# Historic Architectural Review Commission

## Item 5.b.3.

CL3- Request for revisions to approved plans - #513 William Street- 1 Pinder Lane- Architect Thomas E. Pope (H10-04-14-408) Revision to previously approved H09-10-16-1192 and H09-07-17-798. New chimneys on 513 William Street as per plans and new pool, deck and landscape.

# Front Elevation—513 William St.

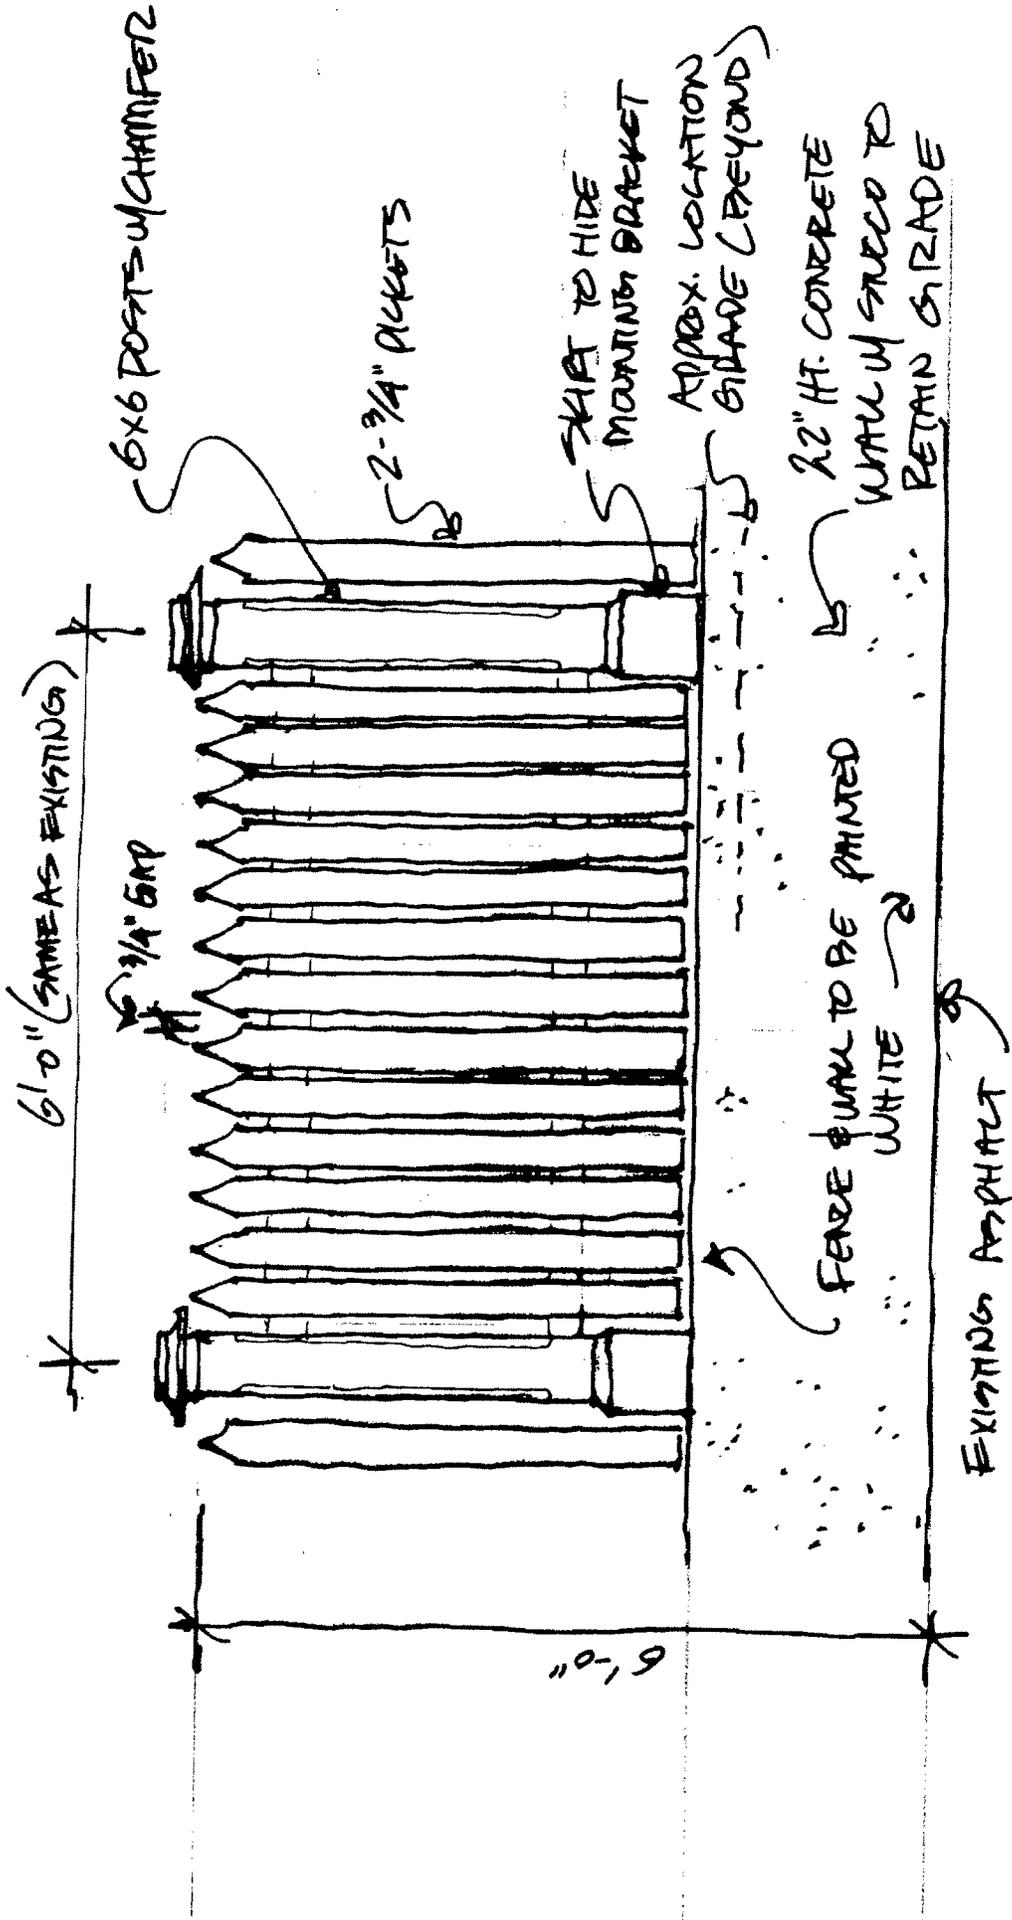
The new plans propose the construction of a swimming pool, a deck and landscape design between the two properties. The plans also include two new exterior chimneys to be located on the south and north elevations on 513 William Street. The proposed exterior chimney on the north elevation will be approximately 19'-6" from ground to top. The second chimney, which will be right next to the right of way facing Pinder Lane; will be approximately 22'-9" high. The tallest point of the house is approximately 23'-6" high from grade to ridge. Both chimneys will be built with brick.

- *(3) Roofing materials and forms used in new construction must be visually compatible with the existing historical and architectural context of the streetscape and neighborhood.- Staff understands that the proposed chimneys, particularly the one at the south facade, facing Pinder Lane, are not visually compatible with the historic character of the streetscape. The proposed chimney on the south facade will be approximately 2'-6" setback from the right-of way. It is staff's believe that the proposed 22'-9" high chimney will be too close to the right of way and will change the streetscape character of this small Lane. For the proposed chimney on the north facade only the flue will be seen from William and Pinder Lane, the chimney will be located behind an existing bump out.*

*dormers, scuttles, vents or skylights. Such features may be allowed on roof surfaces not visible from a public right of way. Both proposed chimneys will be exterior elements that, because of their required height, will change the roofline.*

- *Additions, alterations and new construction (pages 36-38);*
  - **(1)Siting-** *New construction must conform to all current city easement, setback and building requirements. No existing buildings shall be relocated and no new structure shall be placed closer to the sidewalk, street or visible alley, than the distance of pre-existing historic structures. The proposed two chimneys will be located within the required side setbacks. A variance will be needed in order to build the proposed chimneys.*

It is staff recommendation to this commission that the two proposed chimneys are inconsistent with the existing guidelines. Moreover the proposed chimney on the south façade will be too close to Pinder Lane. Staff recommends to this commission to deny the design of two chimneys, as proposed.

Site Plan

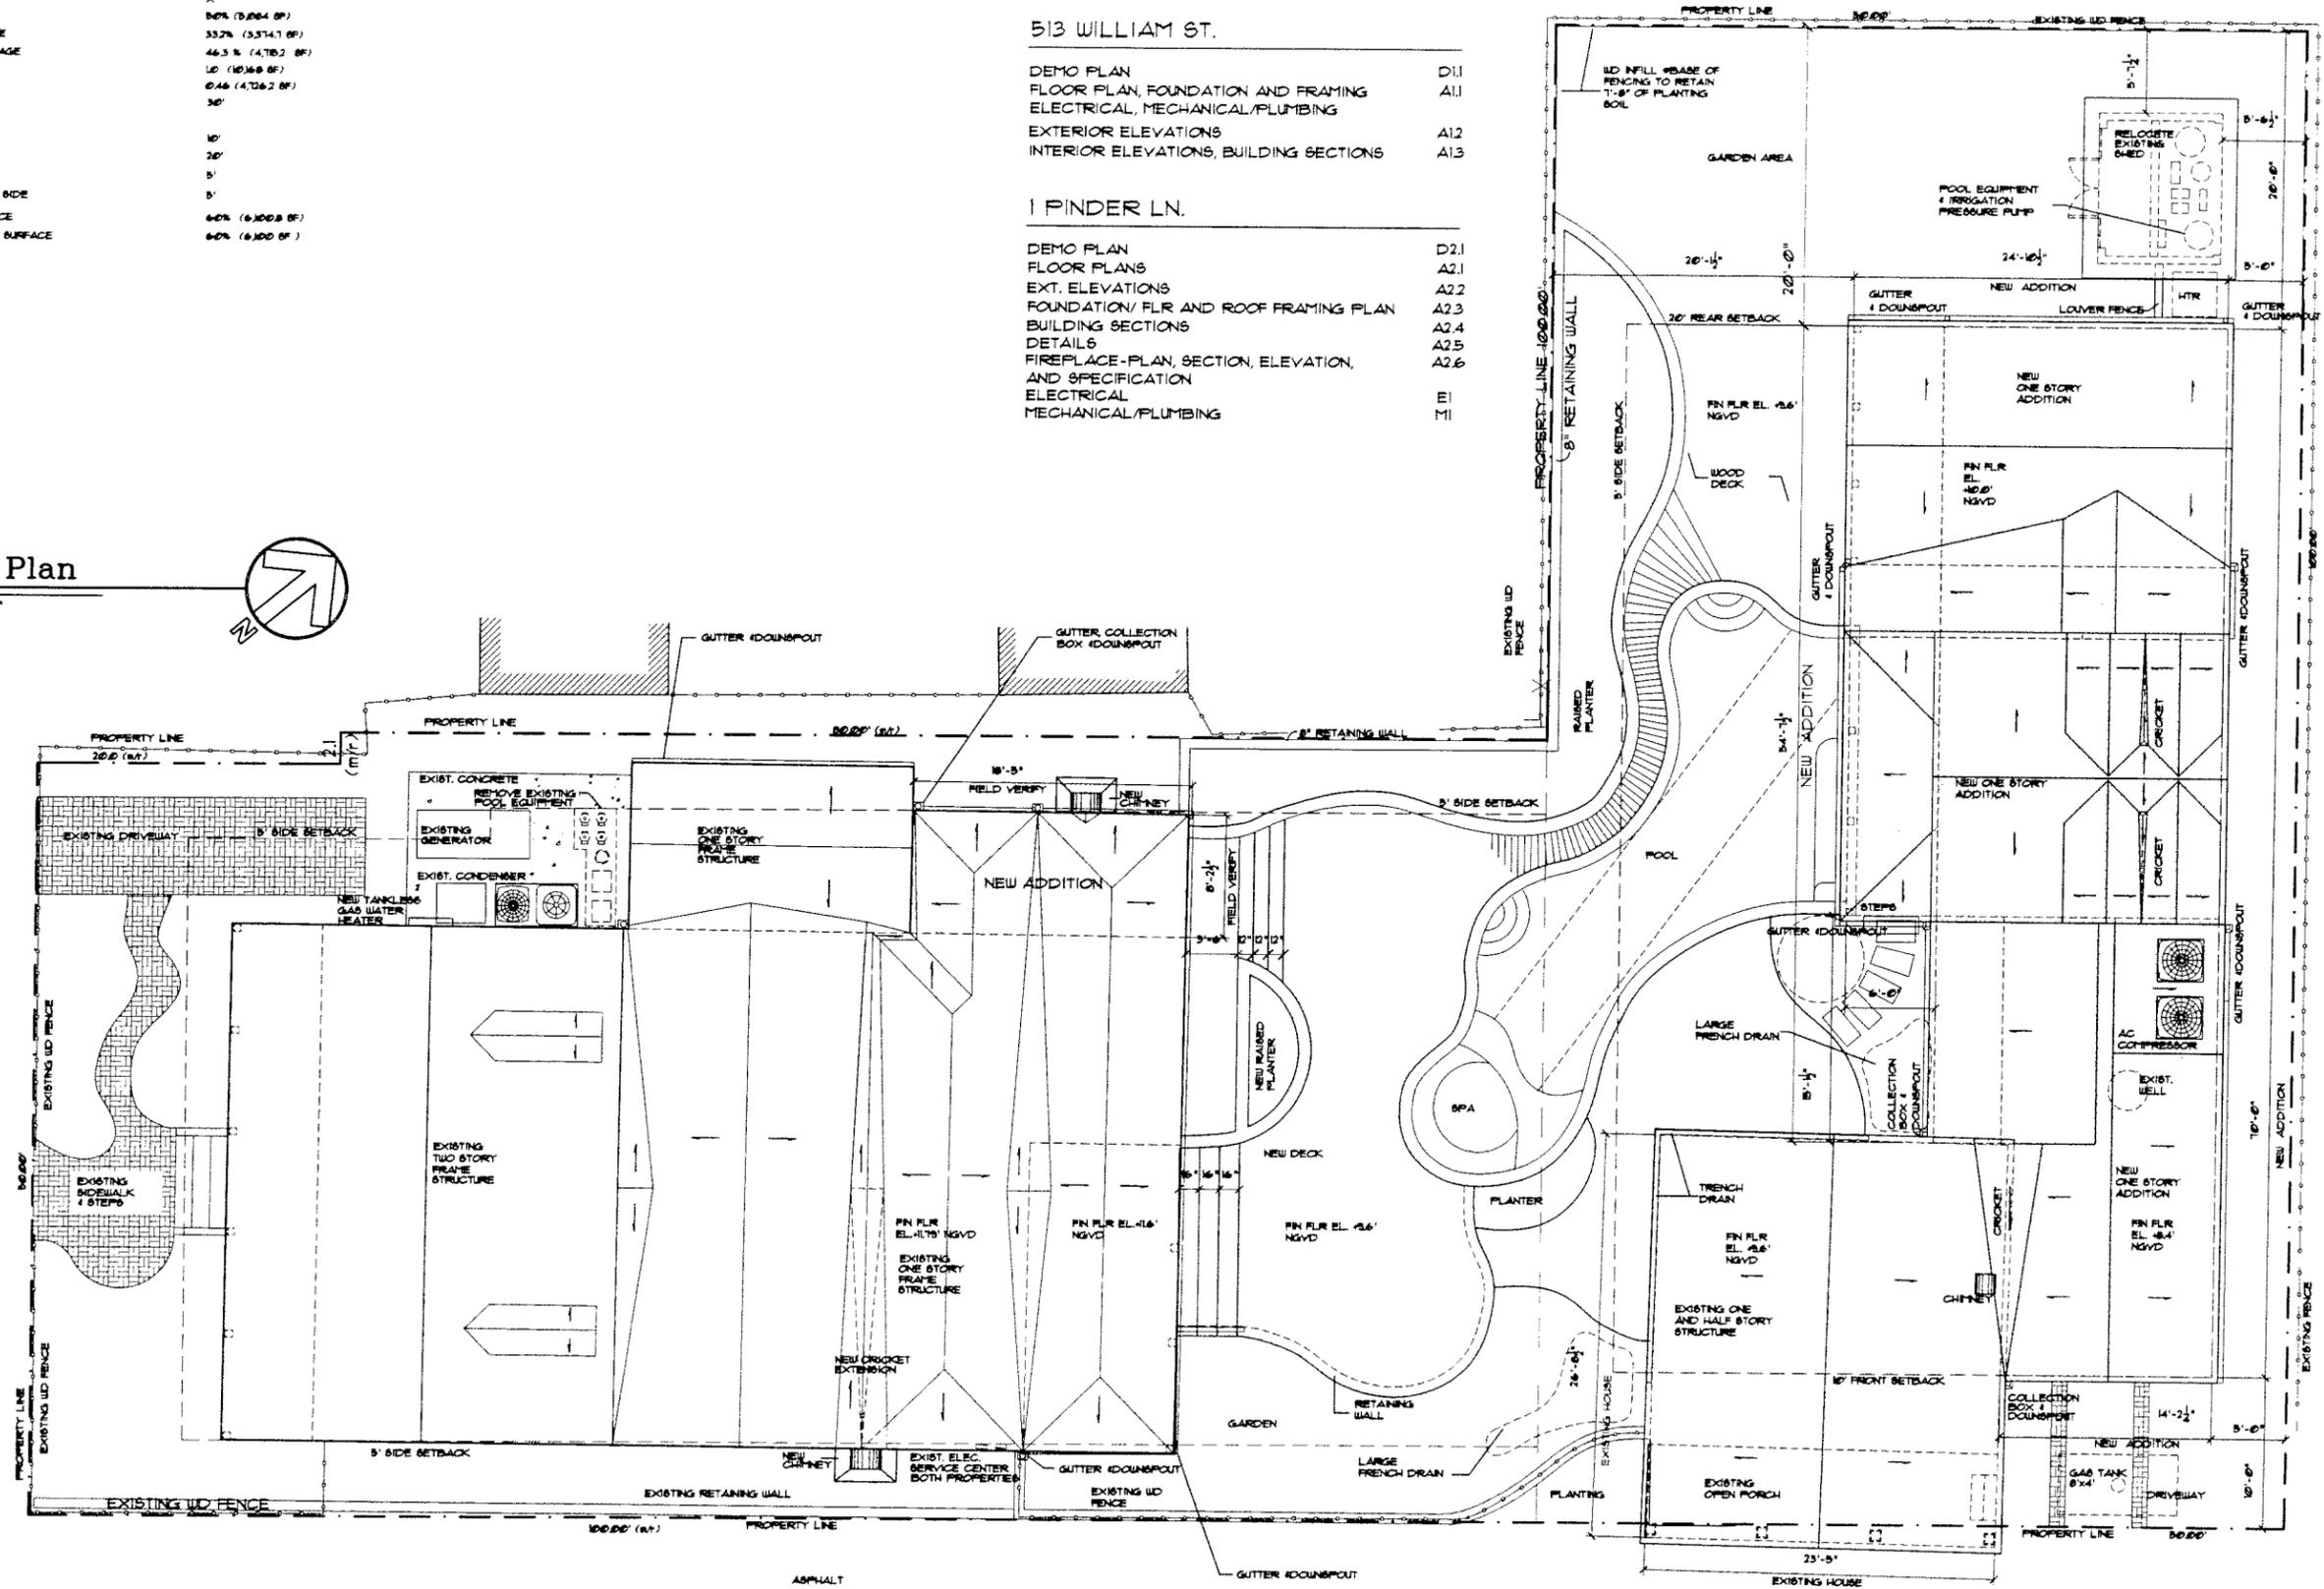
The plans also propose a new swimming pool, deck and landscape that will be located on the back yard of 513 William Street, between the two buildings. A white wood picket fence over a concrete wall, with an overall height of 6'-0" is proposed between the two houses, facing Pinder Lane.

Staff understands that the proposed swimming pool, new deck and landscaping design are harmonious with the historic urban context and recommends approval.
